XDiavel Seat Plate Update  
Models: Model Year 2016 XDiavel;  
Model Year 2016 XDiavel S (all country versions)  
**Service Bulletin SRV-TSB-16-007**

Date: Tuesday, October 18, 2016  
To: Dealer Principal, Service Manager; North American Dealer Network  
From: Richard Kenton, Technical Director; Jonathan LaForte, Technical Manager

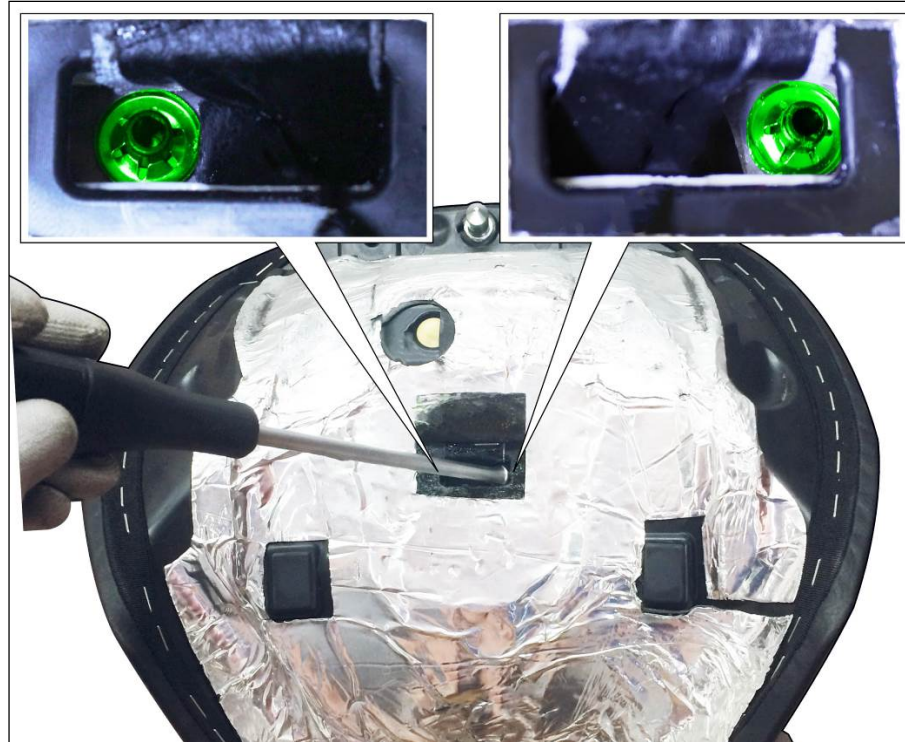
- 1) Remove rider seat.
- 2) Working on the seat's lower side, make an opening in the thermal protection where the plate is fastened, paying attention not to damage the **band (1)**.

- 3) Install the **2 clips part no.85044251A** on the ones already present in line with the plate pins and position them as shown in the figure.

To facilitate the operation, we advise the use of a socket spanner.
